# DART SERVICE INSTRUCTION

TO AMEND IIN-D412-702-3 REV. A OR EARLIER

THE PURPOSE OF THIS DSI IS TO CORRECT THE HARDWARE CALLED OUT IN THE D412-702-071 KIT.

| MFG. APPR.   | N/A   | DSI 9612                               | SHEET 1 OF 2           |

FIGURE 25.18 DART D412-702-071 PILOT/CO-PILOT SHOULDER HARNESS KIT (REF: ICA D412-702)

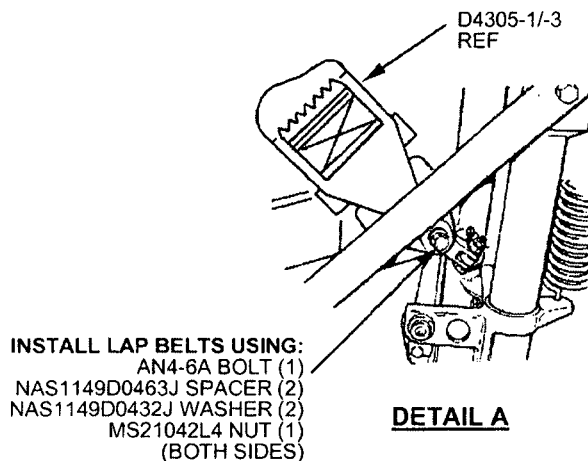
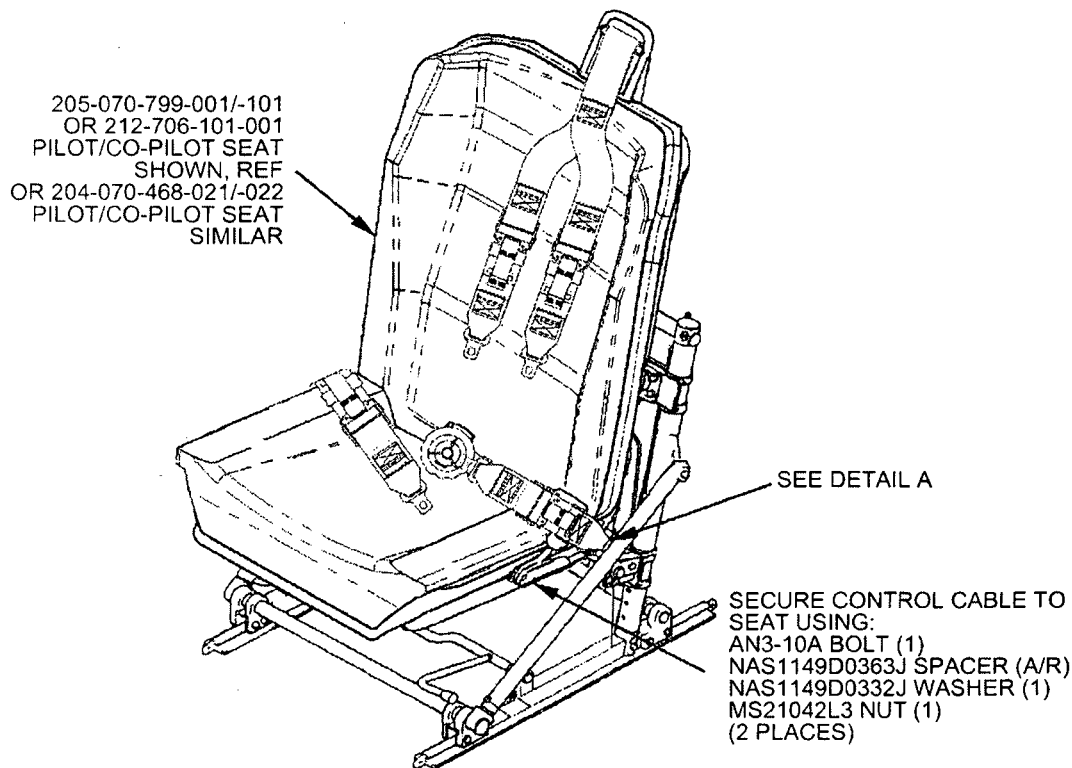
#### 4.0 CHANGES

FIGURE 2. - DART D412-702-071 LAP BELT INSTALLATION (REF: IIN-D412-702)
